**REQUEST FOR ADDITIONAL INFORMATION
ON AIRCRAFT HAZARDS – PARTIAL RESPONSE
DOCKET NO. 72-22 / TAC NO. L22462
PRIVATE FUEL STORAGE FACILITY
PRIVATE FUEL STORAGE L.L.C.**

**RESPONSE TO MARCH 9, 2001 NRC REQUEST FOR ADDITIONAL INFORMATION
REGARDING AIRCRAFT AND CRUISE MISSILE HAZARDS AT THE
PRIVATE FUEL STORAGE FACILITY**

Ceiling @ 9,000'

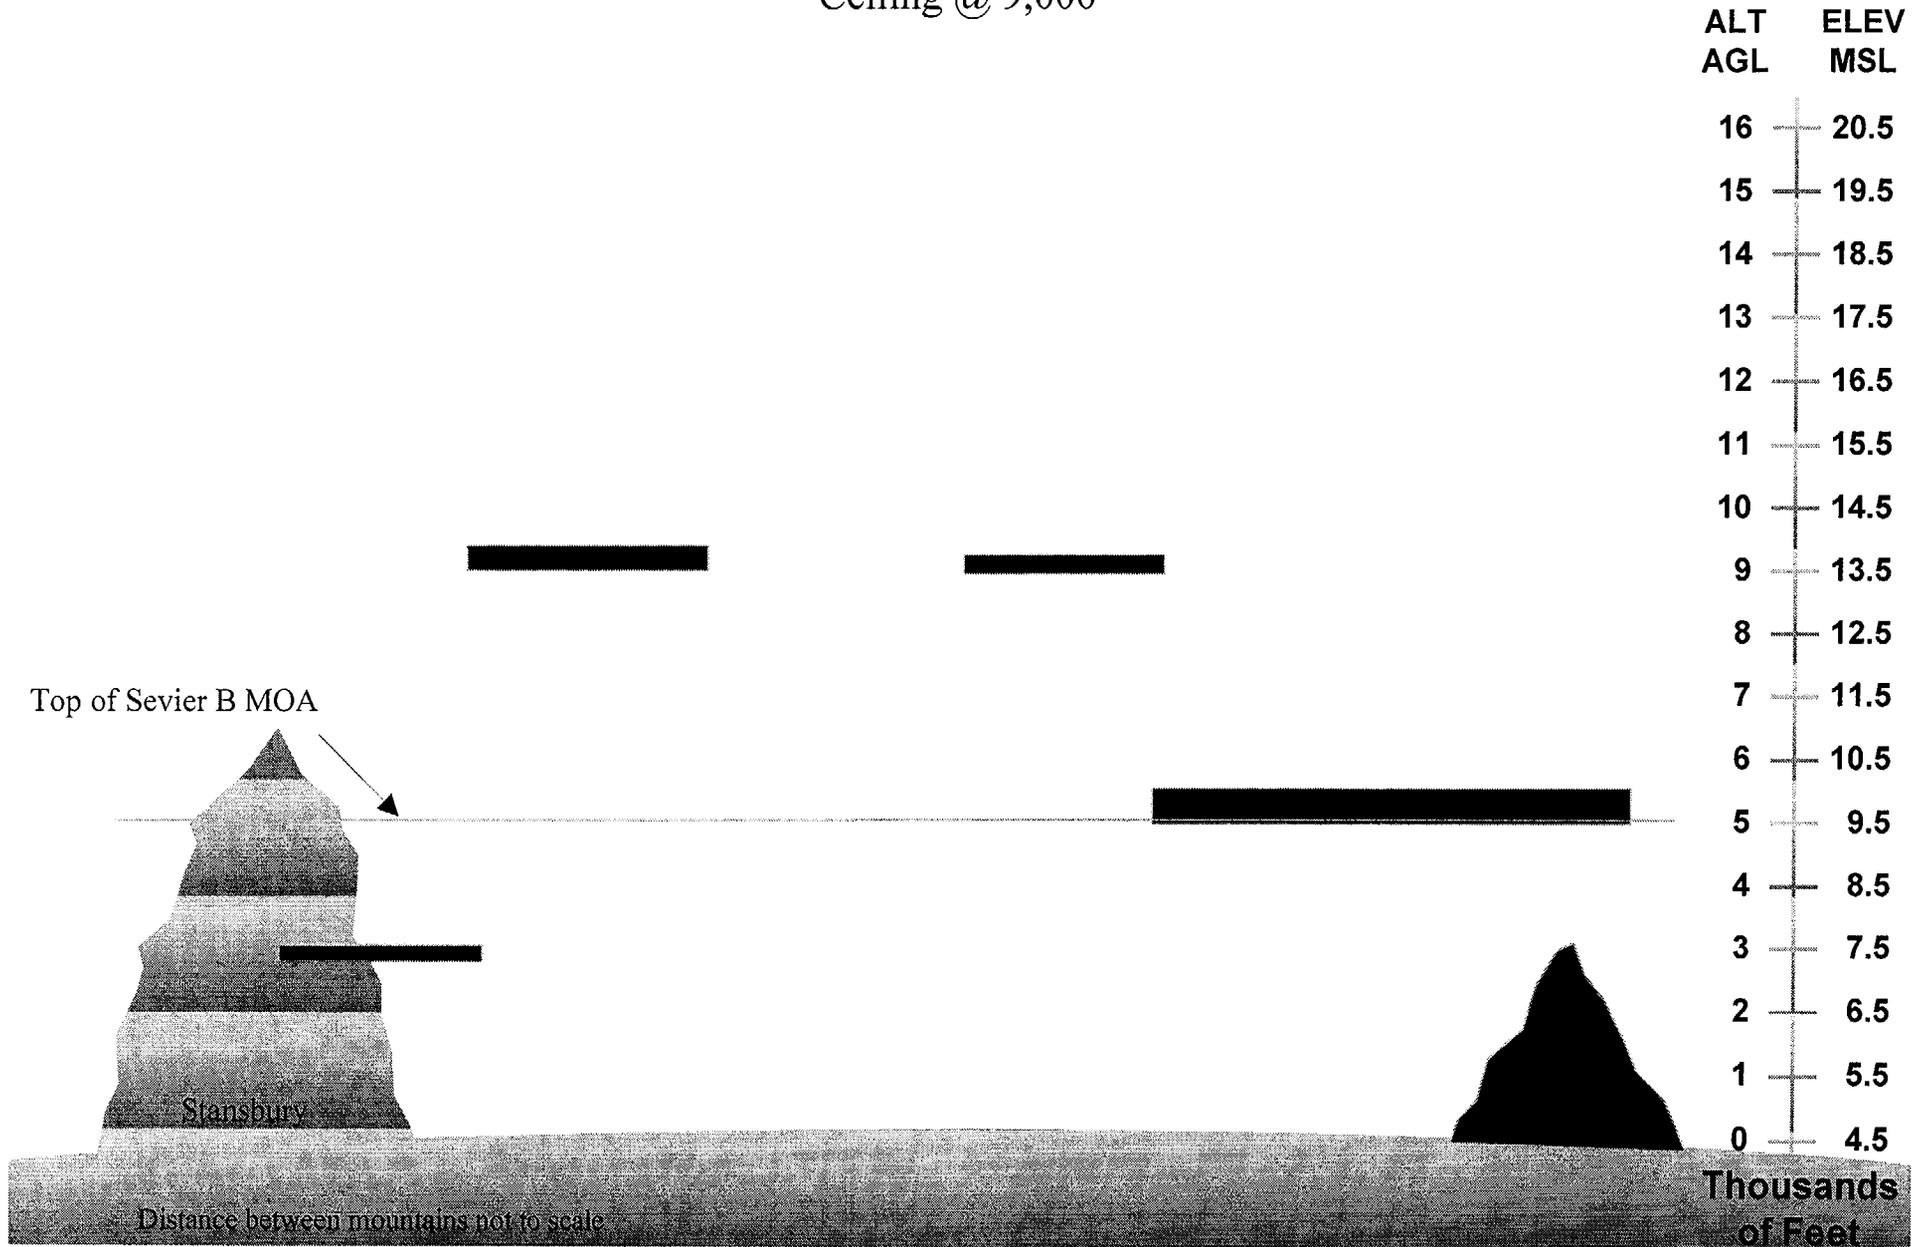
Figures 9-9 through 9-12 show examples of the ceiling and visibility which correspond to the Sevier B MOA. As can be seen from the AWS data, this is the prevailing ceiling and visibility condition 91.5% of the time. In essence, pilots should be able to maintain VFR in the Sevier B MOA the vast majority of the time.
